Architectural Review Board Staff Report

Project Type: Site Development Section Plan

Location: 11 Arnage Road

Description: **River Crossings, Lot 4 (Holiday Inn Express)**: A Site Development Section Plan, Landscape Plan, Lighting Plan, Architectural Elevations and Architect's Statement of Design for a 3.17 acre tract of land zoned "PC" Planned Commercial District located east of Arnage Rd., north of Chesterfield Airport Road.

SHEET
A2.01
OF X

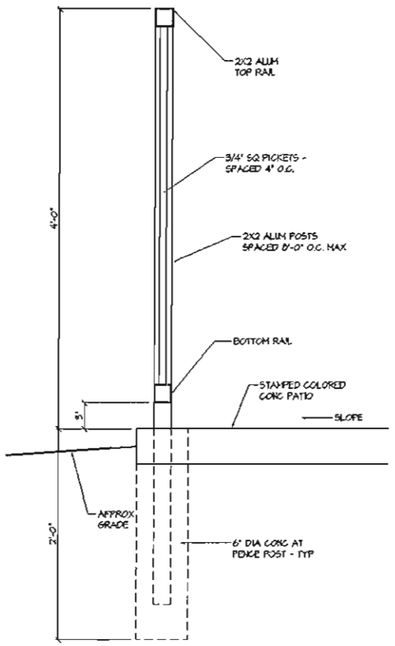
1. ***While the primary building material is supposed to be brick in two colors, the architectural elevations and renderings portrays the building colors differently in each of the three different versions.***

2. ***The rooftop units are shown as screened but questions arose as to whether the entire units are adequately screened. Consistency in depicted height of equipment between the elevations and the sight line study is needed.***

4. ***Adequate information regarding the window and fence colors and materials was not provided.***

6. ***While the integration of additional brick patterns for variation should be considered, the vertical stripes of red brick on the façade detract from the simplistic form of the building.***

The applicant has submitted revised architectural drawings for the ARB's consideration.

The parapets have been raised and the applicant has confirmed that the sight line study is accurate.

The applicant will be bringing a material sample of the proposed glass and fence.

Brick soldier courses have been added above the windows of all four elevations and the red brick stripes have been removed from the façade.
